AGENDA
MAPLE PLAIN PLANNING COMMISSION
MAPLE PLAIN CITY HALL
September 4, 2014
7 p.m.

Request by Tracy King/Lucky Dog for Preliminary Site Plan Review to Allow Construction of a New Commercial Building and Site Development for the Property Located at 1765 Spring Avenue

To:	Planning Commission
From:	Mark Kaltsas, City Planner
Meeting Date:	September 4, 2014
Applicant:	Tracy King/Lucky Dog
Owner:	Bill Woods
Location:	1765 Spring Avenue

Proposal for 1765 Spring Ave

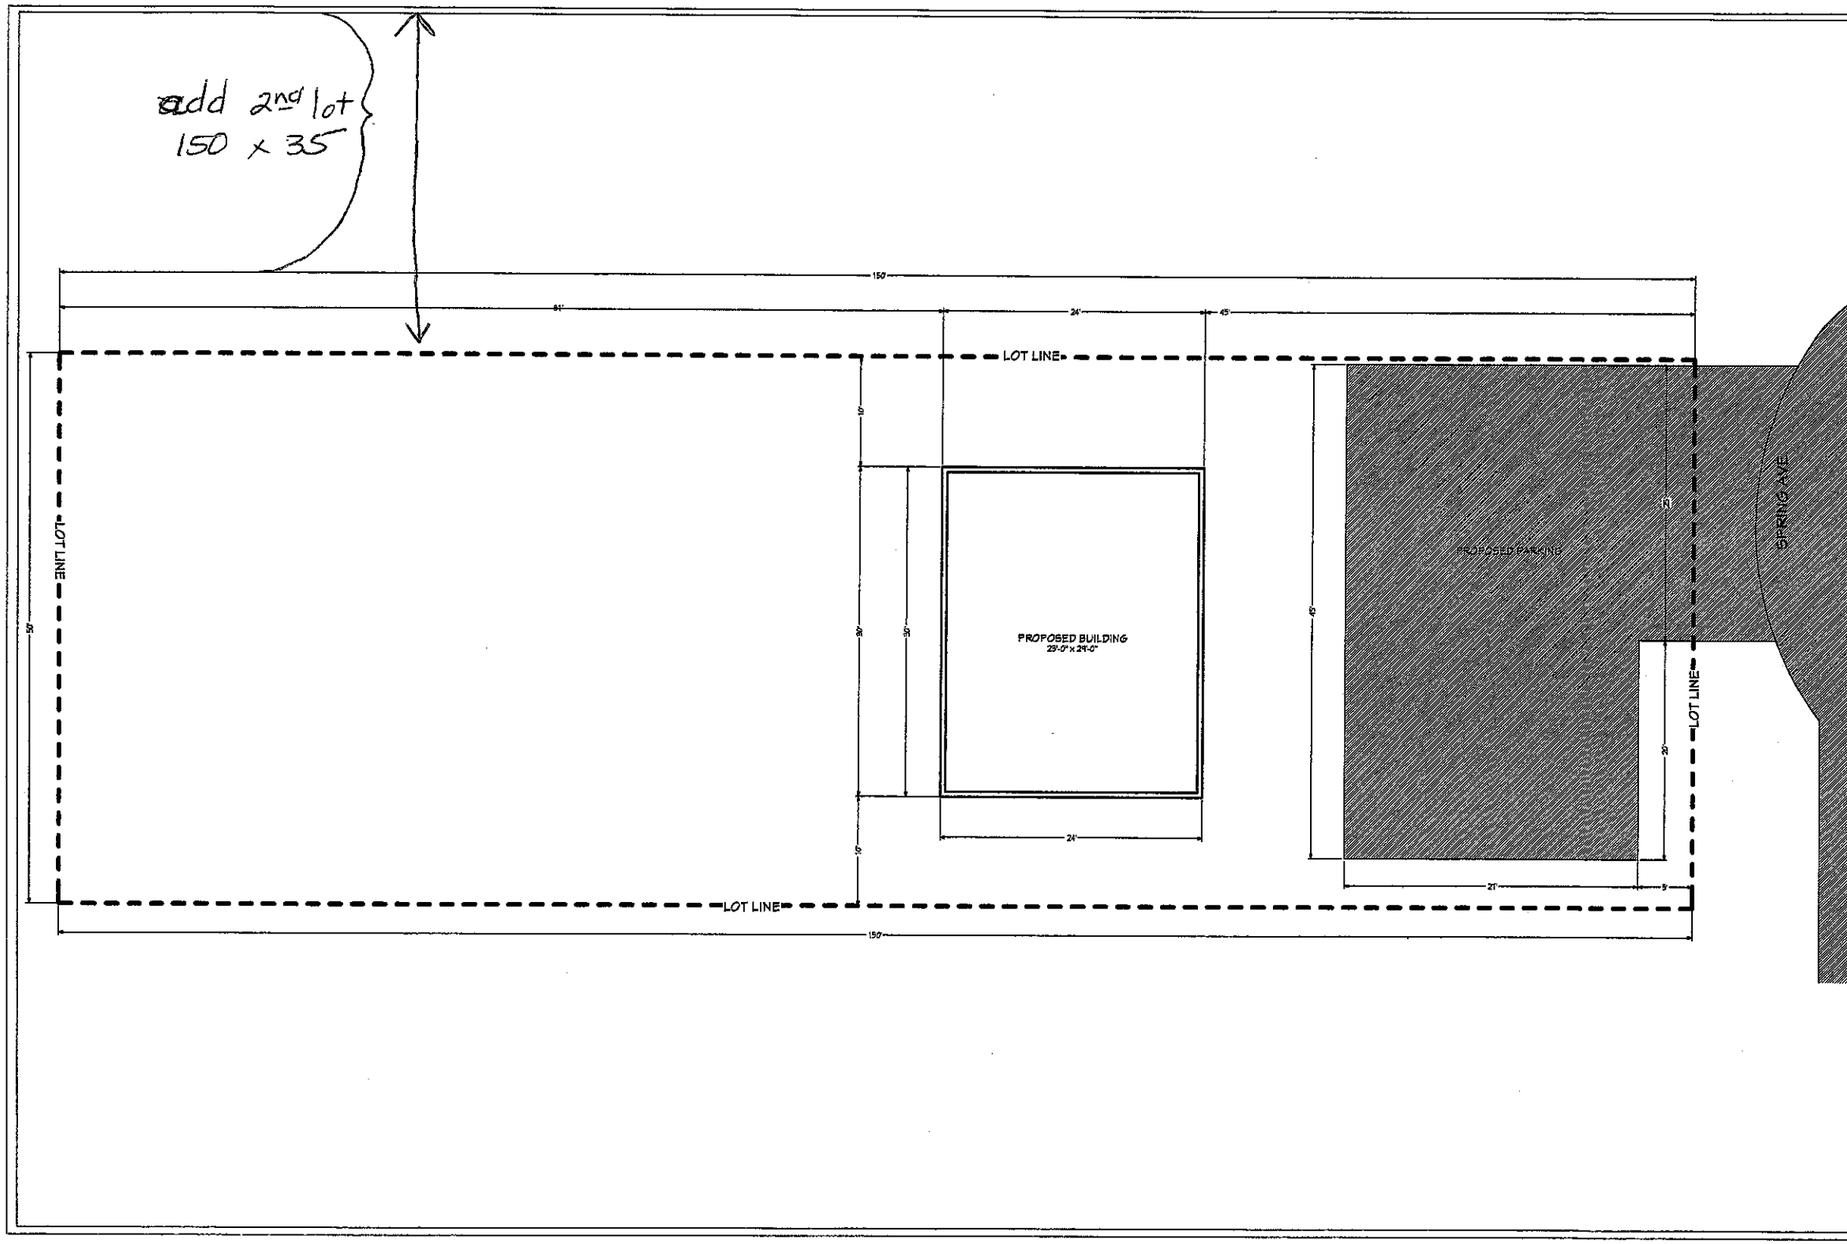
- 60% openings, window, doors, fenestration, (23% proposed)
- 35% wood, brick, stone, hardie board siding
- 5% other materials

- 40% windows, fenestration (25% proposed)
- 50% wood, brick, stone, hardie board siding
- 5% other materials

The applicant is proposing a "cottage" type structure that appears to generally be consistent with the intent of the City's design guidelines for the downtown district. The applicant has proposed siding (would need to be hardie board) for the majority of the building. The proposed hardie board siding would meet the requisite siding percentages for the first and second floors. The proposed fenestration for the first and second floors does not meet the recommended percentage as directed in the guidelines. The City will need to determine if the proposed building is consistent with the intent of the design guidelines (see attached guidelines)

In the MU-D Zoning District, the required parking setback from Highway 12 is 50 feet. Complying with the required setback would make it difficult to construct an off-street parking area on this property. The City does mention in the ordinance that there are going to be certain properties that require relief from this requirement. The applicant will likely require a variance from the 50 foot Highway 12 setback. The applicant will need to meet the 10 foot setback from is proposing to meet

Parking lot lighting shall be arranged as to deflect light away from any adjoining residential property and from the public streets. The applicant will need to provide the City with proposed lighting for the parking lot that meets all applicable criteria.

The applicant has not provided the City with a landscape plan. Landscaping will need to be provided between the proposed parking lot and the adjacent residential property as well as along the Spring Avenue and Highway 12 frontages.
